Access Compliance Report

Public Rights-of-Way

(Curb Ramps)

Intersection ID: 5055	Main Street: GRABILL_DR	Cross Street: MASON_DR	Location: NW
ADA ID: 4D09764749E1	Ramp Type: Perp	Initial Pass/Fail: Fail	Overall Compliance: No
Severity Score: 33.75			
Codes/Mitigation Info/Possible Solution		Field Measurements/Component Compliance

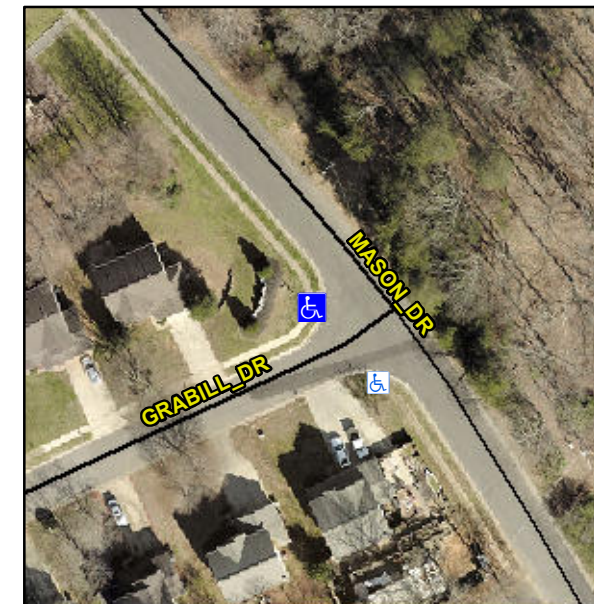
Not Found, R304.5.1, R304.2.2

Compliance	Description	Data	Compliance	Description	Data
N/A	Ramp Length (in)	52.0	No	Ramp Slope (%)	20.0
No	Ramp Width (in)	46.0	Yes	Ramp XSlope (%)	1.4
N/A	Flare Type LT	N/A	N/A	Flare Type RT	N/A
N/A	Flare Slope LT (%)	N/A	N/A	Flare Slope RT (%)	N/A
N/A	Flare Traversable LT?	N/A	N/A	Flare Traversable RT?	N/A
N/A	Landing Length (in)	N/A	N/A	DWS Provided?	N/A
N/A	Landing Width (in)	N/A	N/A	DWS Contrast?	N/A
N/A	Landing Slope (%)	N/A	N/A	DWS Length (in)	N/A
N/A	Landing X Slope (%)	N/A	N/A	DWS Full Width?	N/A
N/A	Landing Curb? (Y/N)	N/A	N/A	DWS Offset (in)	N/A
N/A	Shared Landing?	N/A			
N/A	Gutter Ponding?	N/A	N/A	Gutter Slope (%)	N/A
N/A	Gutter Lip Ht (in)	N/A	N/A	Gutter X Slope (%)	N/A
N/A	Painted X Walk1?	No	N/A	Painted X Walk2?	N/A
	X Walk 1 Direction	To SE		X Walk 2 Direction	N/A
N/A	X Walk 1 Width (in)	N/A	N/A	X Walk 2 Width (in)	N/A
	X Walk 1 Slope (%)	1.9		X Walk 2 Slope (%)	N/A
	X Walk 1 X Slope (%)	2.4		X Walk 2 X Slope (%)	N/A

Remove & Replace Entire Ramp.
